Washington Village
Norwalk, Connecticut
FMC/FME 2014-01124

Response to CTDEEP Comments

July 24, 2014

Re: **Washington Village, Norwalk
Clarification of CTDEEP Comments**

DAY STREET
ROADWAY PLAN
AND PROFILE - 2

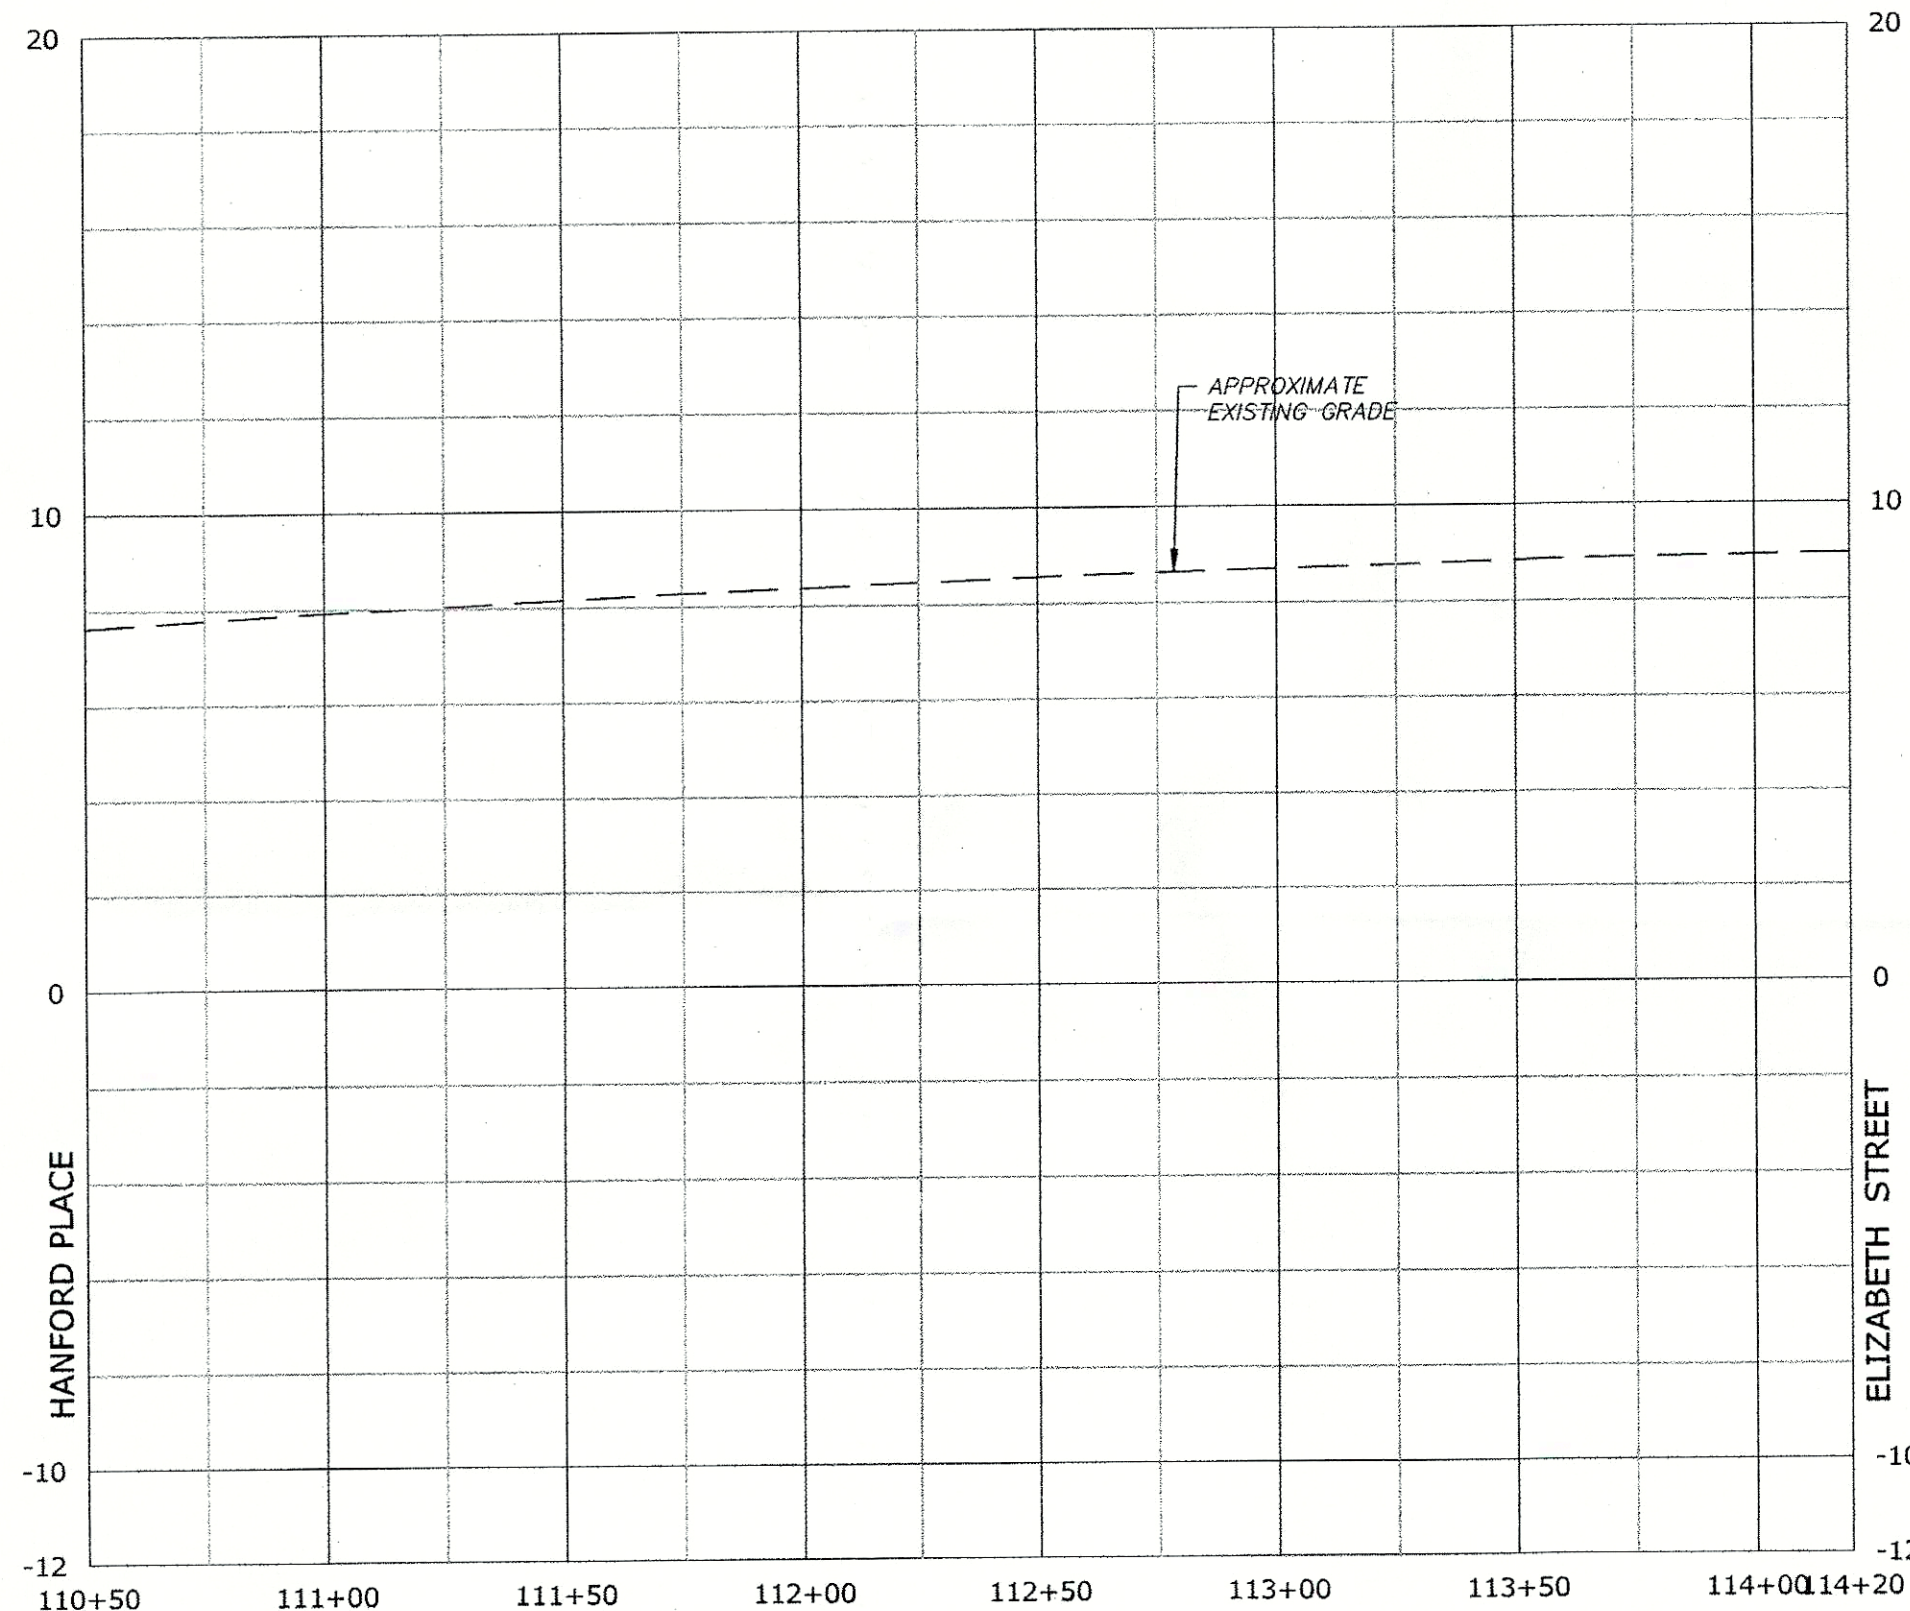
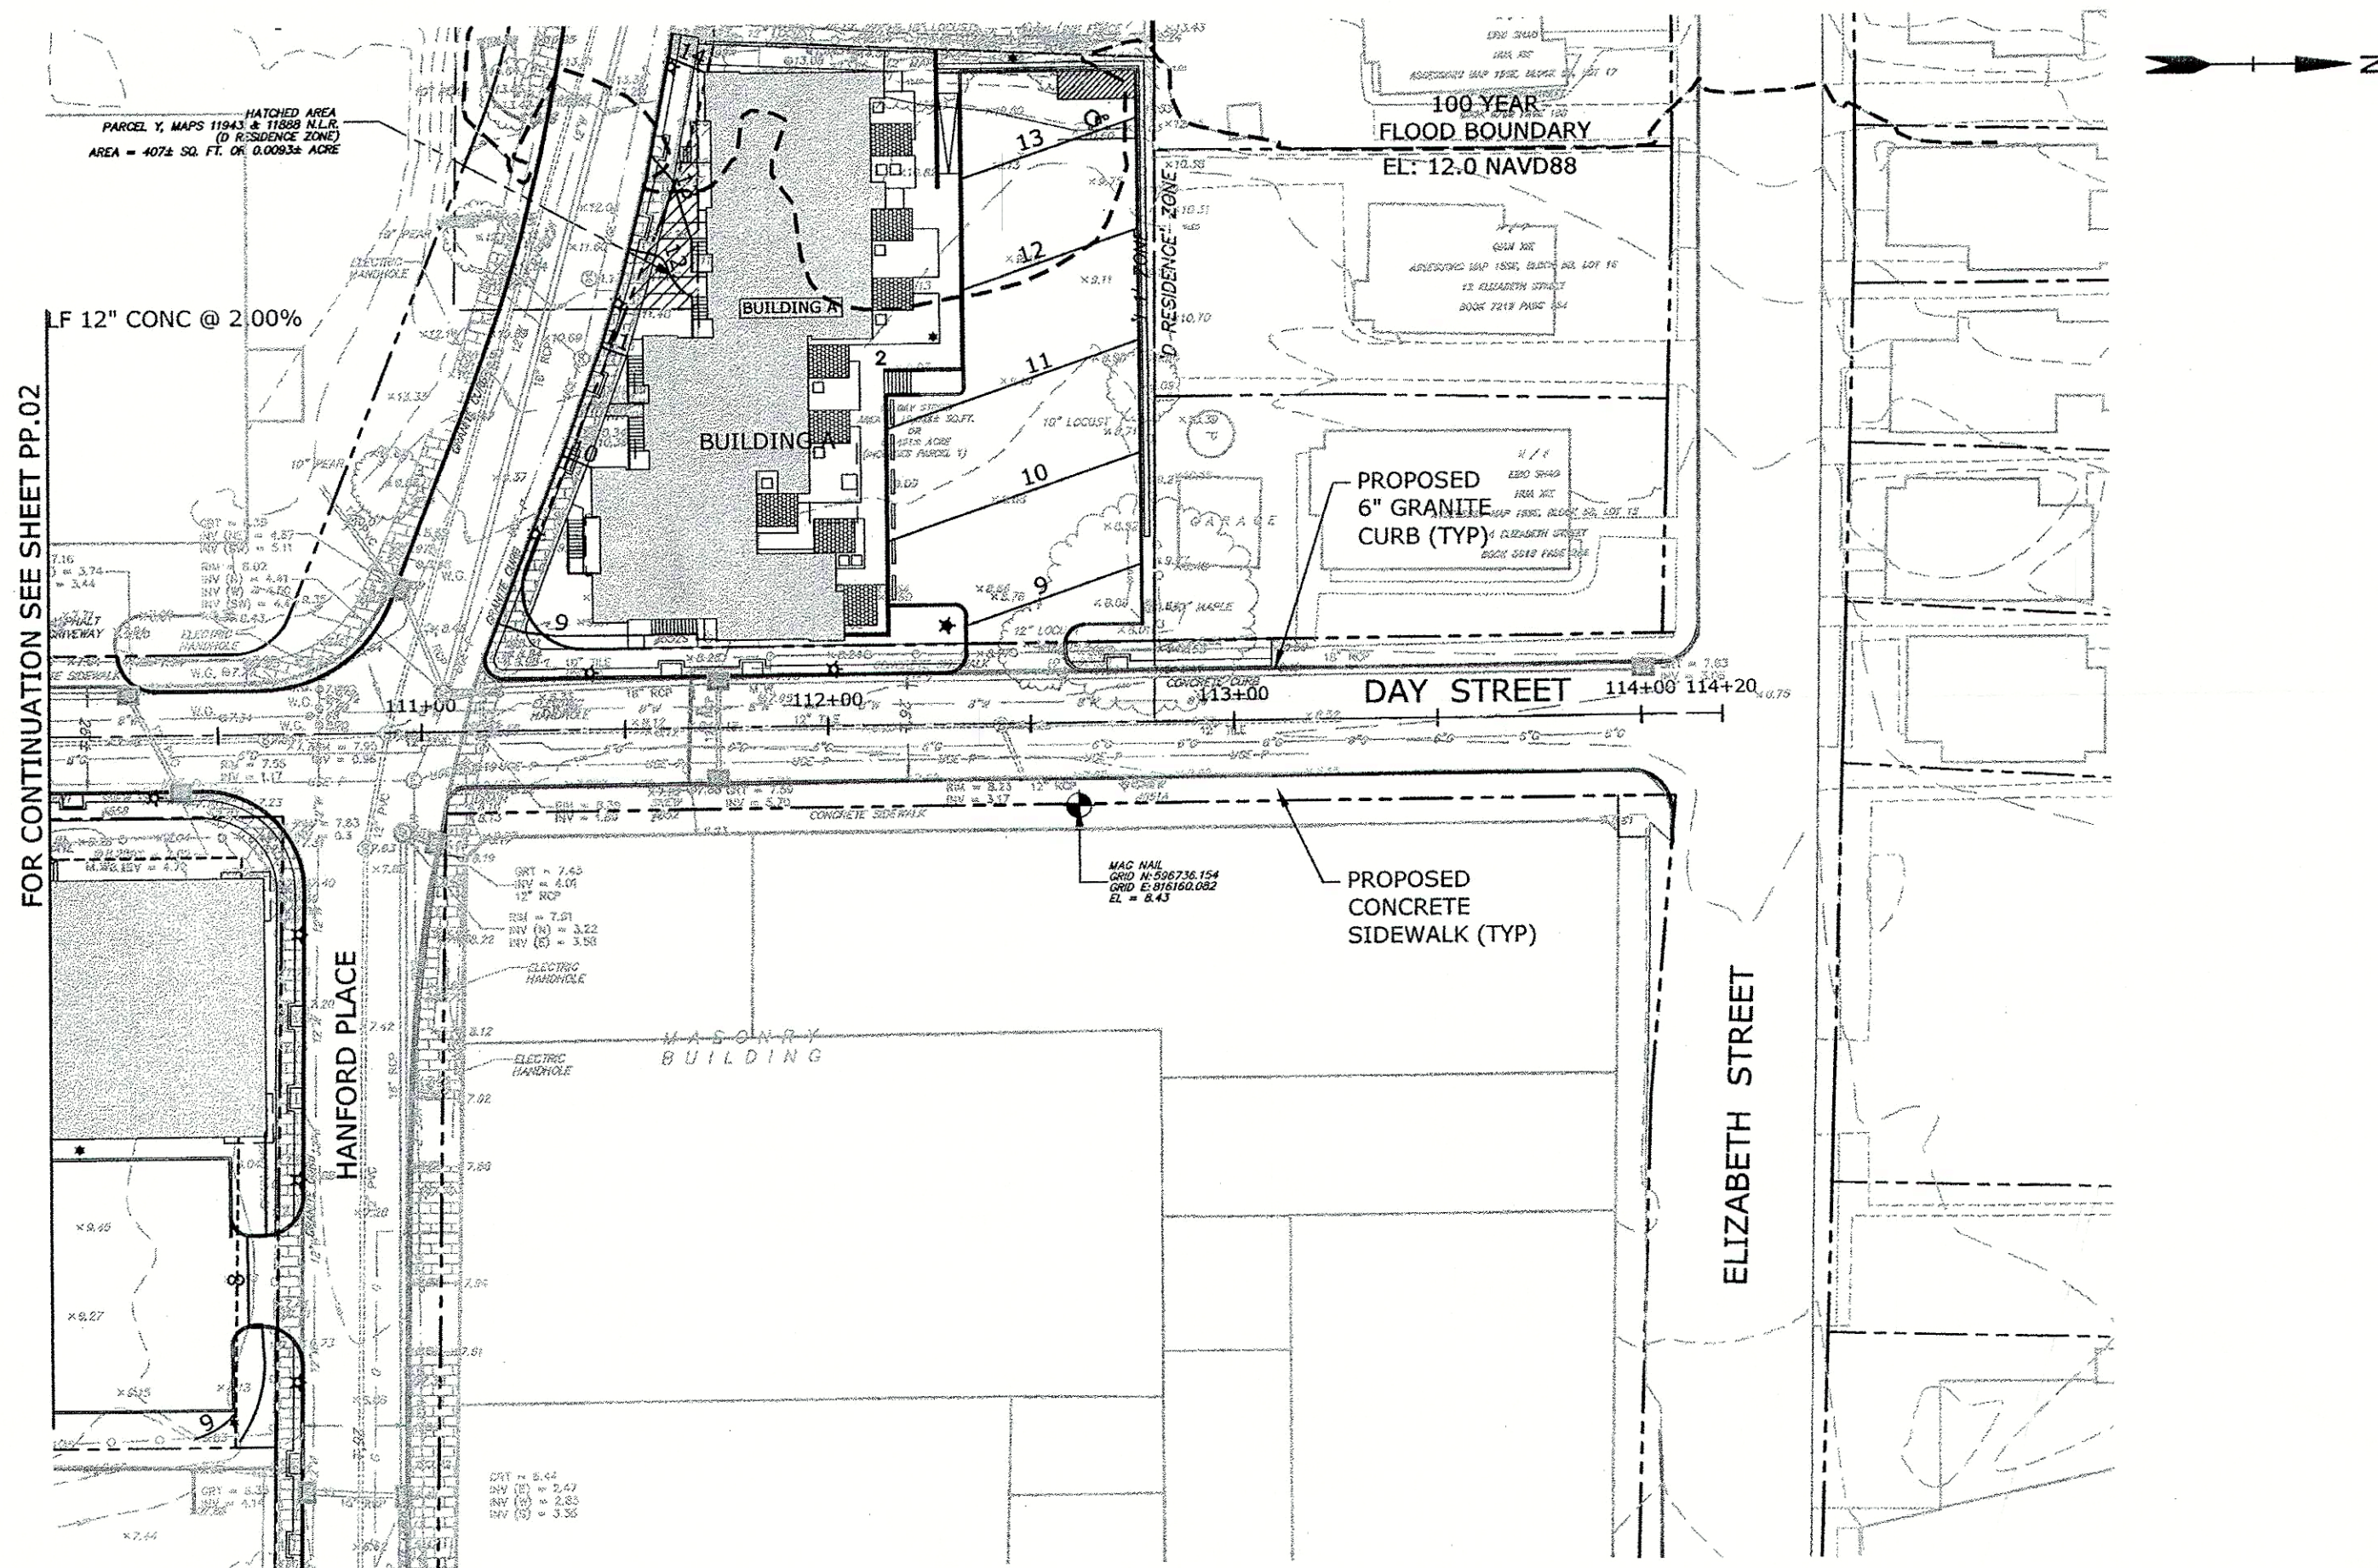
- **Updated drainage plan and profile of Raymond and Day Streets, including more information on location of drainage structures.**
 - PP.01 Raymond Street Roadway Plan and Profile
 - PP.02 Day Street Roadway Plan and Profile – 1
 - PP.03 Day Street Roadway Plan and Profile – 2

CONCEPT PLAN

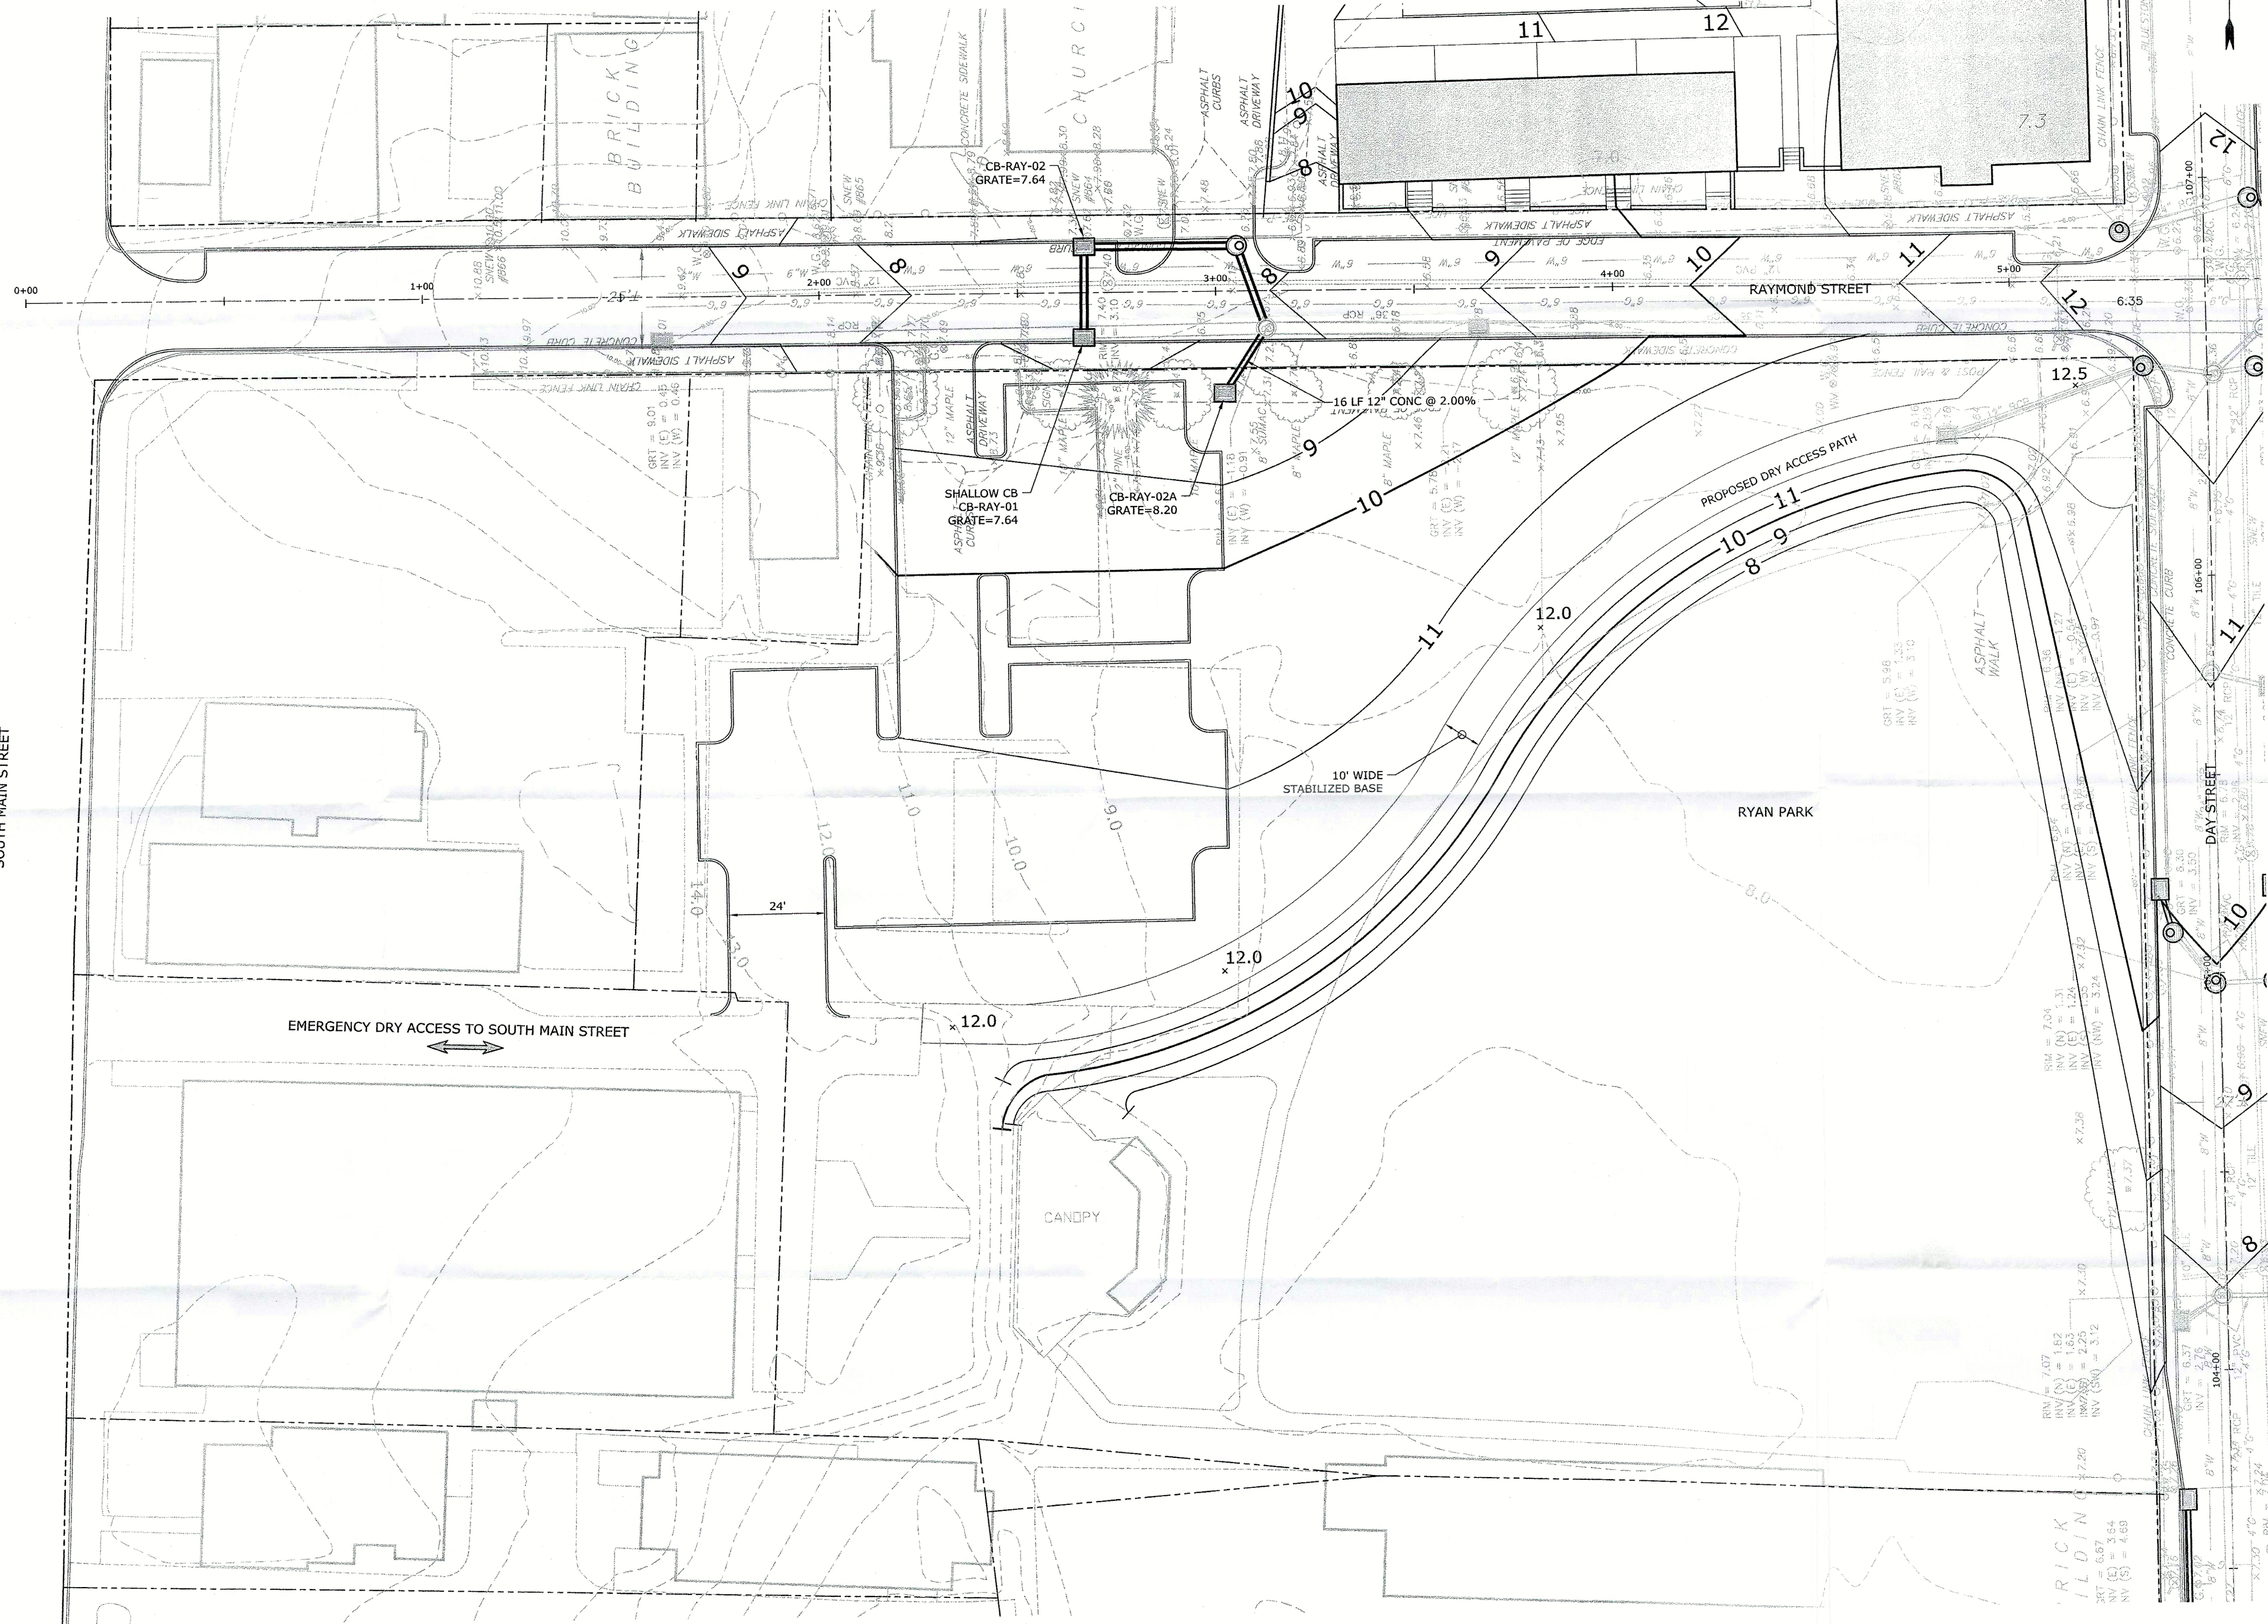
The City has also received funding for the Ryan Park improvements, as mentioned in the letter from the City of Norwalk Redevelopment Agency. We have prepared a concept plan showing how access will be achieved across the park, by constructing a level access path, with a stabilized surface suitable for emergency vehicle passage, across the park at or above elevation 12 NAVD88. The proposed improvements will not adversely impact drainage, and the drainage from portions of the park has been incorporated into the Raymond/Day roadway design. The following is included in Appendix C:

- **Ryan Park Concept Plan, Drawing RP.01**
- **Design contract with the City of Norwalk for the Ryan Park Dry Access Design.**
